Administrative Approval Action

Case File / Name: ASR-0009-2022 DSLC - 300 Hillsborough St City of Raleigh
Development Services Department
One Exchange Plaza
Raleigh, NC 27602
(919) 996-2492
currentplanning@raleighnc.gov
www.raleighnc.gov

This development consists of a hotel, apartment units, a restaurant, structured parking and associated infrastructure. The total proposed size of the development is 711,428 square feet.

City Administration finds that this request, with the below conditions of approval being met, conforms to the Unified Development Ordinance. This approval is based on a preliminary plan dated October 13, 2022 by Mcadams.

NORTH ELEVATION

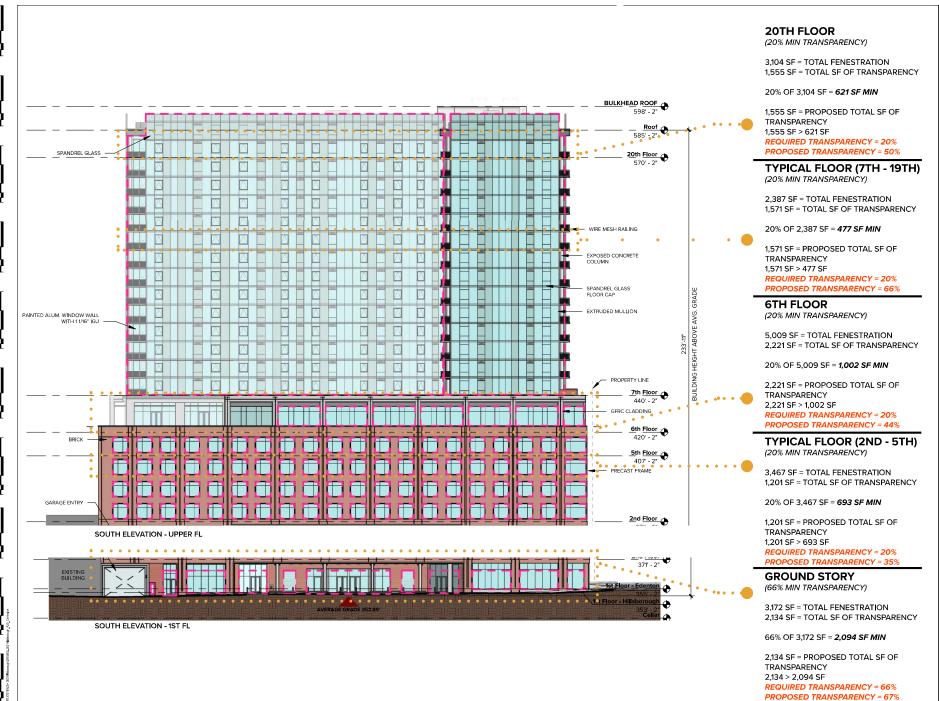
vi) a design alternate to the required minimum 66% ground story transparency set forth in UDO Sections 1.5.6. and 3.2.6.F. that results in 48% ground floor transparency along W. Edenton St.;
